Application Number
167621
Sheet
90 of 208

FAILS TO COMPLY

MITCHELL CHILDCARE CENTRE
BLOCK 18, SECTION 11 CORNER DARLING &
HEFFERNAN STREET, MITCHELL, ACT

Rudds
Consulting Engineers
Comments 12/02/2018

ROOF PLAN			
Drawn	Date	Scale	Project Number
Author	1:250	A3	A17041
Review	Date	Project Leader	Designer
Checker	Date	Designer	Drawing Number
PRELIMINARY			SK 105
ACCT

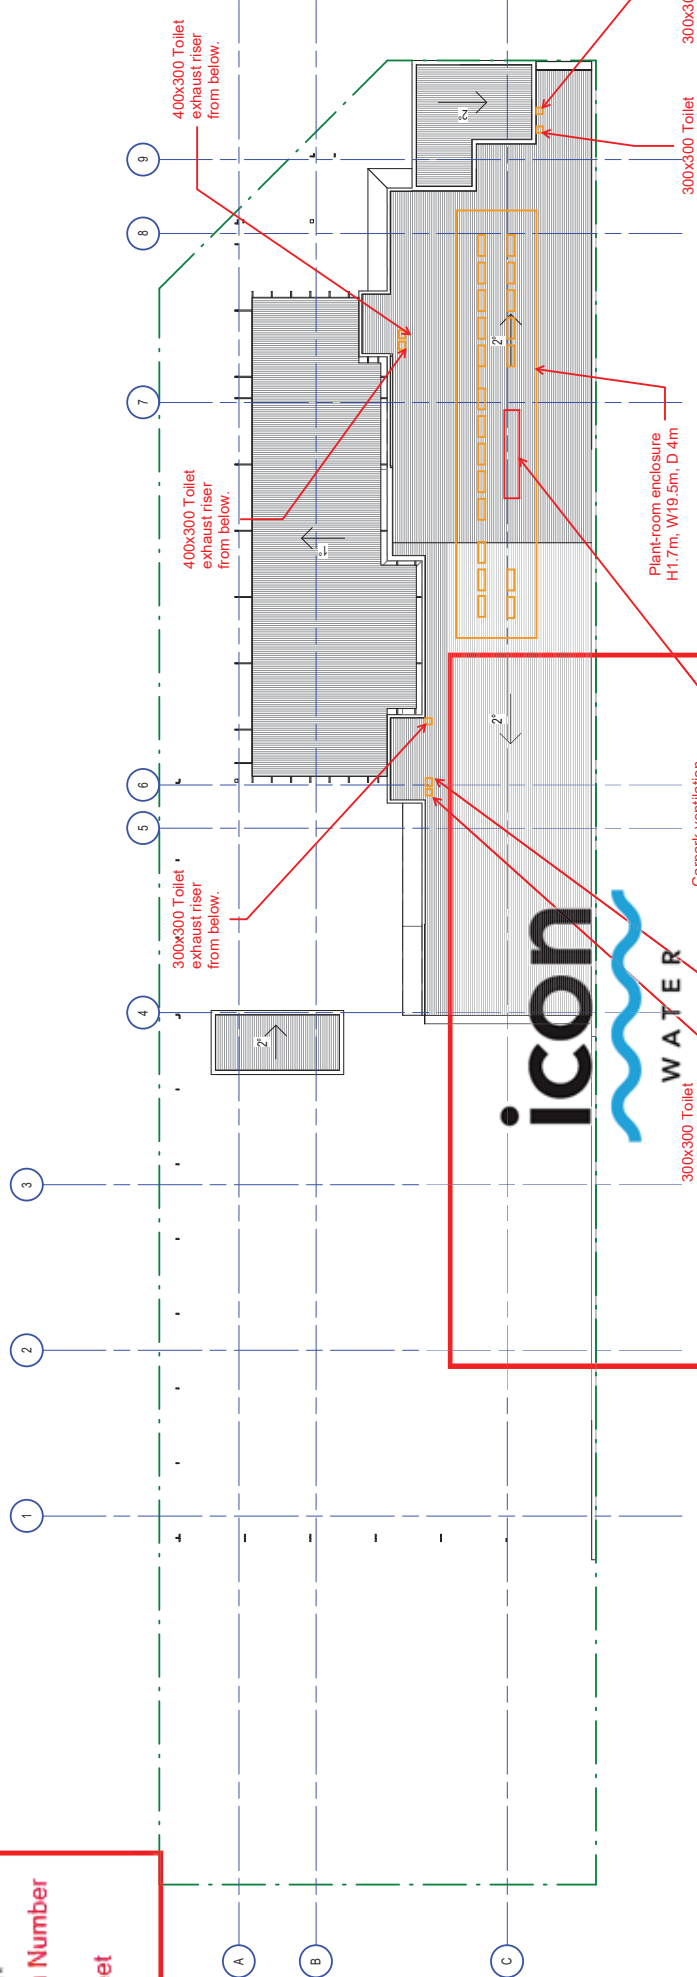
300x300 Toilet exhaust riser from below.
400x300 Toilet exhaust riser from below.
Carpark ventilation ductwork required

The design depicted in this document is not accepted because it fails to comply with conditions listed on the accompanying statement.

SECTIONS			
Drawn	Date	Scale	Project Number
Author		1:100	A3 A17041
Review	Date	Project Leads	Drawn
Checker		Designer	Drawing Number
PRELIMINARY			ACT#
			SK 300

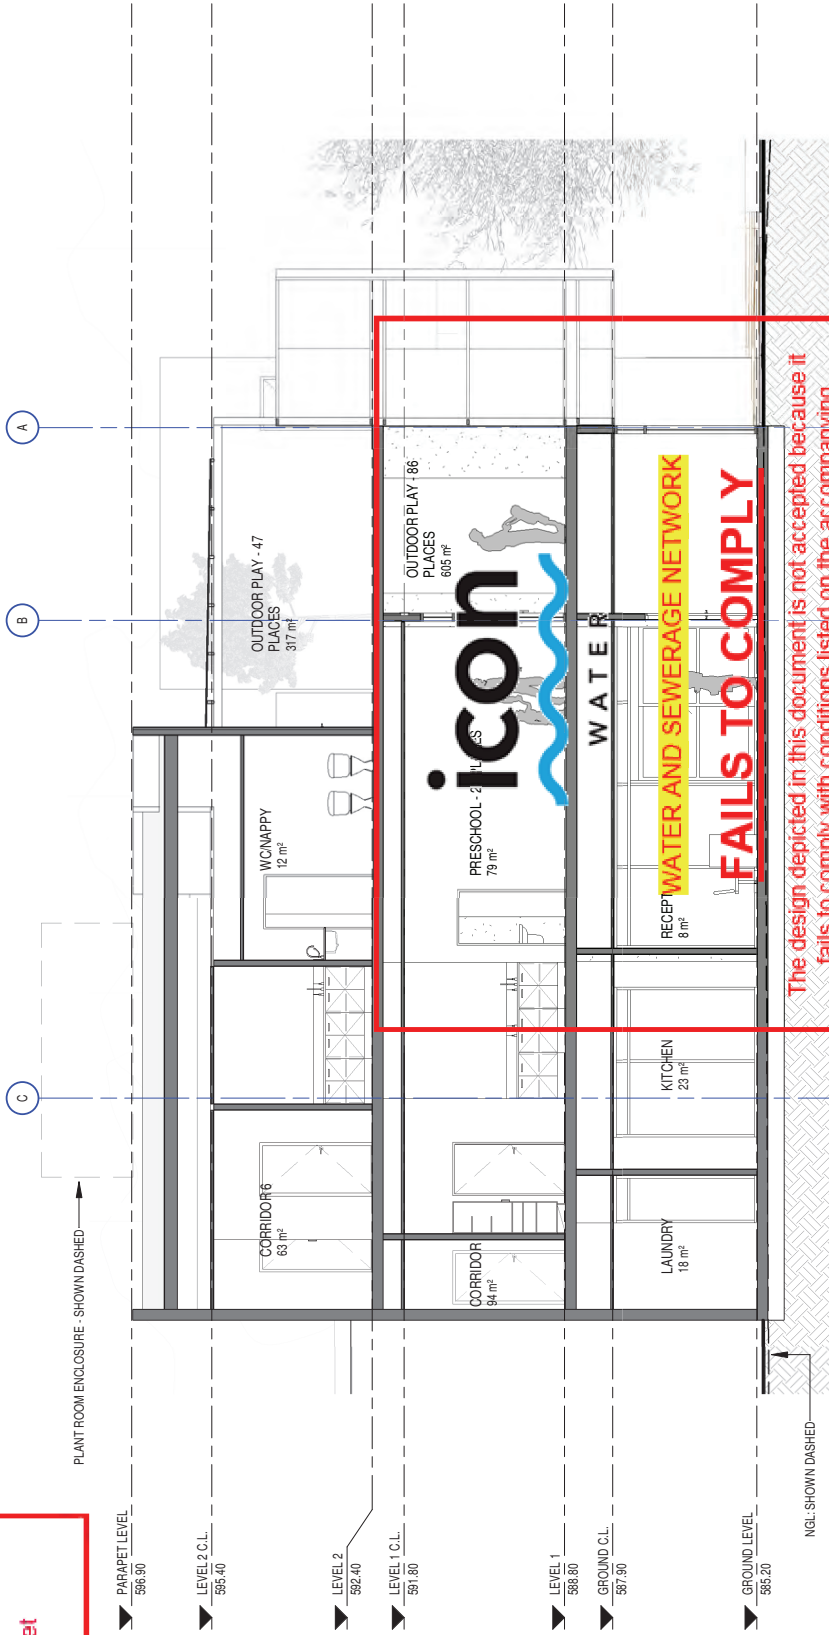
The design depicted in this document is not accepted because it fails to comply with conditions listed on the accompanying statement.
